**Interference Considerations Involving
The “Big LEO” Mobile Satellite Service Ancillary Terrestrial
Component, The Broadcast Auxiliary Service,
And Verizon’s Proposal for Relocating MDS Operations To The
2490–2500 MHz Band**

By Kessler and Gehman Associates, Inc.

Figure 1. OOBE Interference – MSS/ATC to MDS at 2490-2500 MHz

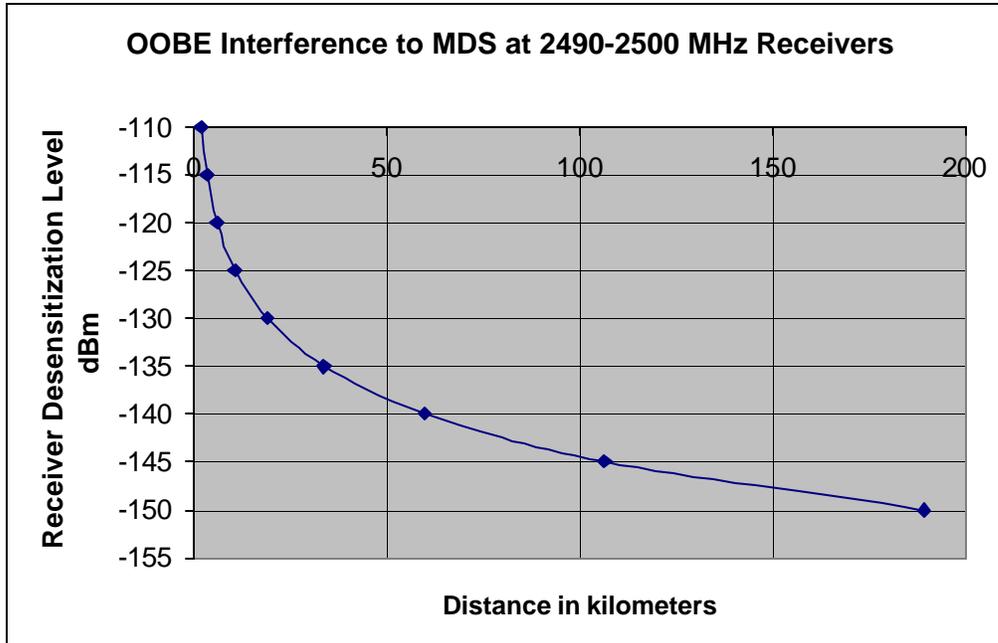
Section 25.254(a)(4) of the FCC’s rules specifies that an MSS/ATC licensee maintain its OOBE to a maximum allowable OOBE EIRP of -44.1 dBW/30 kHz at the edge of the MSS/ATC licensee’s authorized frequency assignment. An EIRP of -44.1 dBW/30 kHz is the equivalent of -21.09 dBW normalized to a 6 MHz bandwidth. The noise level in a 6 MHz bandwidth is $[-204 + 10\text{Log}_{10}(6,000,000)] -136.22$ dBW. The protection required to avoid a 1-dB increase in the noise floor of an MDS receiver with a 5-dB noise figure is $[-136.22 \text{ dBW} + 5\text{dB} - 5.9 \text{ dB}] - 137.12$ dBW/6 MHz. Therefore, based on the following calculations and as illustrated by Figure 1, MSS/ATC would cause interference to any MDS station relocated under the Verizon proposal if the MDS station were located within 43.0 km (26.7 miles) of the MSS/ATC base station.³ Given that MDS licensees are today using MDS channels 1 and 2/2A to serve the same urban and suburban markets MSS/ATC appears to be targeting, and both will be using cellular network architectures, such separations distances cannot be maintained as a practical matter.

$$\begin{aligned}
 \text{Distance Separation} &= \text{Antilog} [(EIRP/1 \text{ MHz} + \text{Receiving Antenna Gain} - \text{Noise Floor} \\
 &\quad \text{Protection} - 104.5)/20] \\
 &= \text{Antilog} [(-21.09 \text{ dBW} + 17 \text{ dBi} - -137.12 \text{ dBW} - 104.5)/20] \\
 &= \text{Antilog} [(133.03 \text{ dB} - 104.5)/20] \\
 &= 26.7 \text{ miles, or } 43.0 \text{ km}
 \end{aligned}$$

Figure 2. OOBE Interference – MDS to MSS/ATC at 2490 – 2487 MHz from an MDS Base Station Operating at 57 dBm EIRP (not to scale)

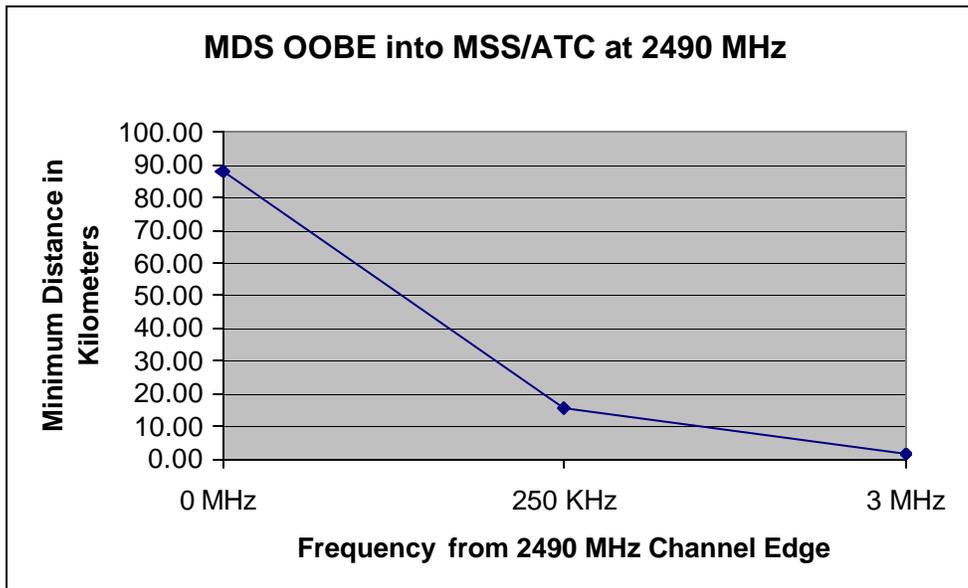
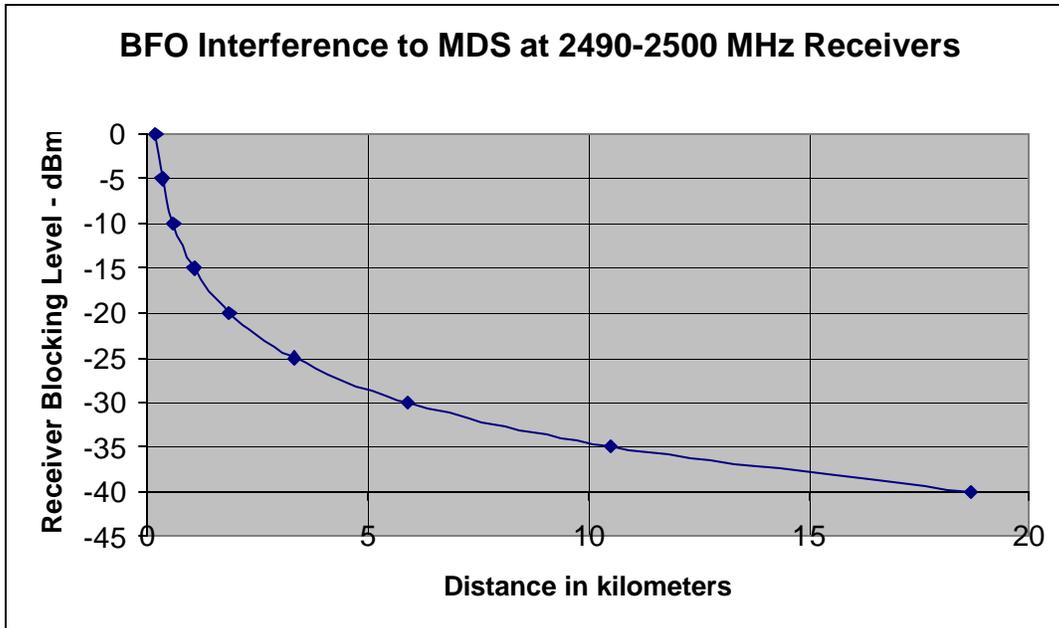
Based on the calculations above, Figure 2 illustrates the required separation distance in kilometers between MDS base stations and MSS/ATC subscriber equipment for operation with a 1-dB impairment to the noise floor. The calculations reveal without a doubt that MSS/ATC subscriber equipment will suffer destructive interference when within line of sight of and in near proximity to an MDS base station operating within the 3-MHz frequency separation required for MDS to achieve its 60 dBc OOBE attenuation. For example, at 2490 MHz which requires 88 Km line of sight separation, an MSS/ATC subscriber just 2 kilometers from an MDS base station, which is a reasonable distance for line of sight to occur, would receive out of band emissions 31.8 dB above its noise floor and be completely desensitized and non operational.

The same MSS/ATC subscriber equipment operating at 2489.75, which requires 15.65-km line of sight separation would, using the 2 km example, also receive out of band emissions from MDS 17.1 dB above its noise floor.

From the above examples, MDS and MSS/ATC cannot operate adjacent to each other at 2490 MHz in the same geographic area.

Figure 4. OOBE Interference – BAS to MDS at 2490-2500 MHz

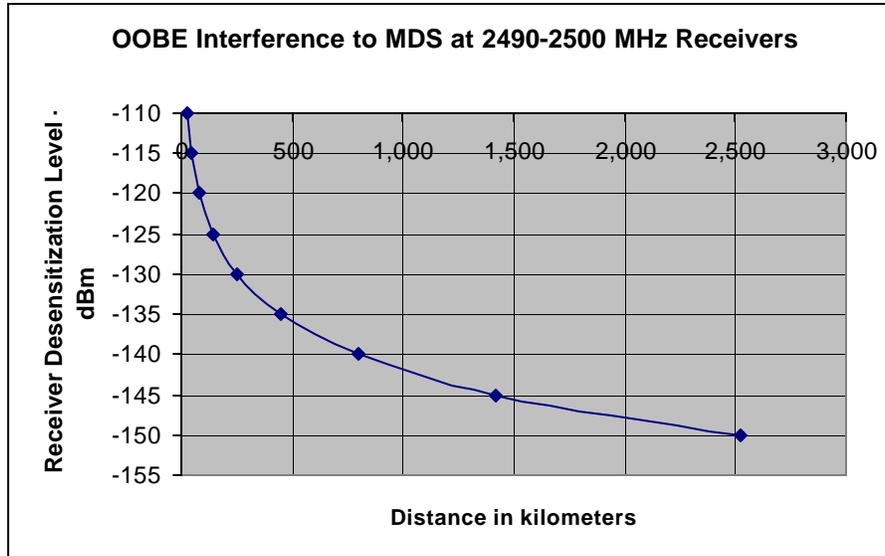
Assuming the MDS subscriber to base station is within line of sight, the required distance between an ENG mobile unit transmitting in compliance with Section 74.637 and an MDS base station operating in Verizon’s proposed 2490–2500 MHz band, ranges from 570 km on channel A9 and 180 km on channel A8. Because ENG units operate in the same geographic areas where MDS licensees are providing service, this sort of separation requirement cannot be met.

Figure 5. Brute Force Overload – BAS to MDS at 2490-2500 MHz.

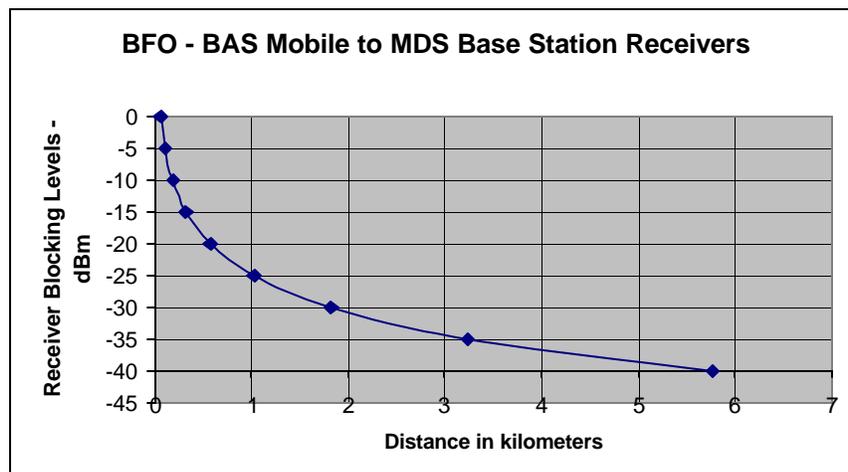
As demonstrated by the calculations below, the required distance between an ENG mobile unit transmitting with an EIRP of 35 dBW on channel A9 and transmitting in the direction of an MDS base station operating under Verizon’s proposed 2490–2500 MHz band and engaged in subscriber-to-base operations is 1.8 km. An EIRP of 35 dBW on BAS channel A9, which has a bandwidth of 16.5 MHz, is equivalent to an EIRP of 30.61 dBW in an MDS bandwidth of 6 MHz. Since the beamwidth of an ENG transmitting antenna is about 12 degrees wide, there would be a sector with a 0.38 km arc and a radius of 1.8 km within which interference would be caused to an area of almost 0.33 square kilometers. Since numerous MDS base stations would be located throughout the ENG market area, there is a clear and apparent threat of harmful interference from BAS/ENG transmissions to MDS base stations.

Distance Separation = Antilog [(EIRP/6 MHz + Receiving Antenna Gain – Noise Floor Protection – 104.5)/20]
 = Antilog [30.61 dBW + 17 dBi – -58 dBW – 104.5)/20]
 = Antilog [(105.61 dB – 104.5)/20]
 = 1.1 miles, or 1.8 km
